MARINE FIELD SERVICE BULLETIN

FSB Number	1319340169
FSB Title	DigiSTREAMER DUAZ GPS Week Rollover
Date	January 9, 2020
Originator	Sean Stanford
Product Group	DigiSTREAMER
Product Name	GPS INTERFACE UNIT DSTR
Product P/N	AS9000-3920

This FSB applies to the AS9000-3920 GPS INTERFACE UNIT DSTR (AS8000-2330 ASSY GPS INTERFACE DUAZ) Week Number Rollover (WNRO) issue.

Old, obsolete Trimble Lassen SK II:

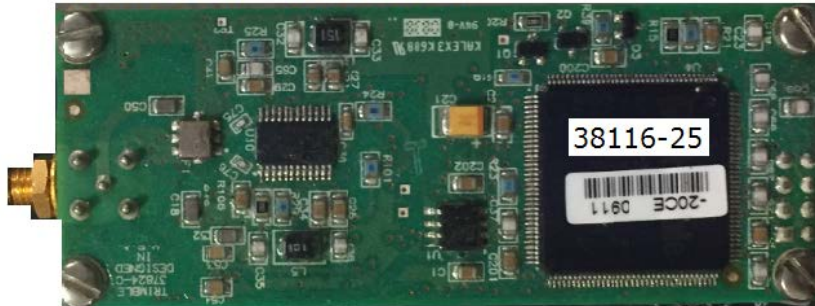
Check the version of GPS Modules in the DUAZ by opening the DUAZ and determine which of the two GPS Modules is in use in their DUAZ.

4. If the Nalecom NLC-SKII-CP2 GPS Module is installed, do nothing as the correct GPS Module is already installed. Reassemble the DUAZ chassis. If the Lassen SKII GPS Module is installed, it must be replaced with a configured Nalecom NLC-SKII-CP2 GPS Module. Continue to step 5.

Qty. 1 ION 1701 132 NLC-SKII-CP2, BOARD GPS MODULE LASSEN SK-II CLONE. This must be programmed by ION to have the required configuration.

5. Unplug the coaxial RF antenna connector from the module.
 6. Remove the Lassen SKII GPS Module by removing the four (4) mounting screws and gently unplugging the module.

7. Install the Nalecom NLC-SKII-CP2 GPS Module by gently plugging in the connector making sure to visually inspect the connection on the bottom of the GPS card to ensure proper alignment.
